Access Compliance Report Public Rights-of-Way (Curb Ramps)

Main Street: GREENVALE Cross Street: WOODSONG Location: S

ADA ID: RPAT220208120423 Ramp Type: Type 1 - Perpendicular Diagonal Initial Pass/Fail: Fail Overall Compliance: No Severity Score: 34

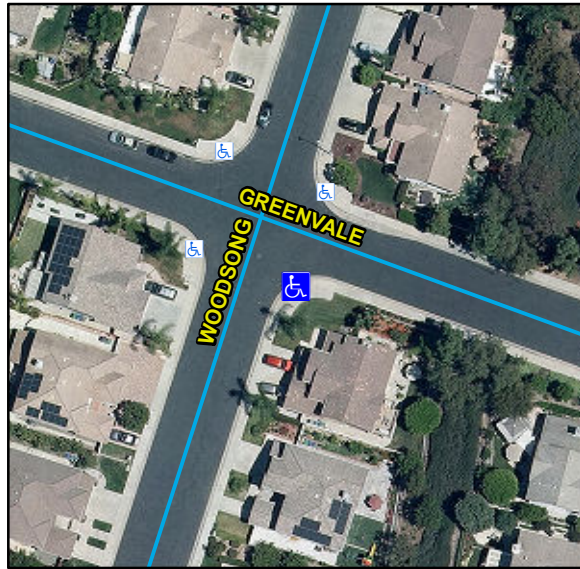
Compliance	Description	Data	Compliance	Description	Data
N/A	Ramp Length (in)	88	N/A	Flare Type LT	
No	Ramp Width (in)	44			N/A
No	Ramp Run Slope (%)	9.37	N/A	Flare Slope LT (%)	N/A
No	Ramp Cross Slope (%)	5.7	N/A	Flare Traversable LT	N/A
N/A	Landing Present	N/A	N/A	Flare Type RT	
N/A	Landing Length (in)	N/A			N/A
N/A	Landing Width (in)	N/A	N/A	Flare Slope RT (%)	N/A
N/A	Landing Run Slope (%)	N/A	N/A	Flare Traversable RT	N/A
N/A	Landing Cross Slope (%)	N/A	N/A	DWS Provided	N/A
N/A	Landing Movement Obstructed?	N/A	N/A	DWS Contrast	N/A
	Landing Movement Type	N/A	N/A	DWS Length (in)	N/A
N/A	Landing Shared	N/A	N/A	DWS Full Width	N/A
N/A	Clear Space	Yes	N/A	DWS Offset Left (in)	N/A
N/A	Clear Space To Crosswalk (in)	N/A	N/A	DWS Offset Right (in)	N/A
N/A	Marked Crosswalk 1	No	N/A	Marked Crosswalk 2	No
	Crossing 1 Direction	NE		Crossing 2 Direction	NW
	Marked Crosswalk 1 Width (in)	N/A		Marked Crosswalk 2 Width (in)	N/A

N/A	Ramp Inside Crosswalk 1	N/A	Yes	Ramp Inside Crosswalk 2	N/A
	Crossing 1 Slope (%)	2.9		Crossing 2 Slope (%)	2.51
	Crossing 1 Cross Slope (%)	4.02		Crossing 2 Cross Slope (%)	4.7
N/A	Gutter Ponding	N/A	N/A	Curb Slope	0.9
Yes	Gutter Lip Height (in)	0		Road Run Slope (%)	5.94
N/A	Gutter Run Slope (%)	N/A		Road Cross Slope (%)	3.4
N/A	Gutter Cross Slope (%)	N/A			
Yes	Overall Surface Condition: Acceptable		No	Perp Joint Present	No
	Cross Gutter Present?	No		Spandrel Present?	No
	Replace Cross Gutter?	N/A		Replace Spandrel?	N/A

Remove & Replace Curb Ramp With Two New Directional Ramps or Equivalent.
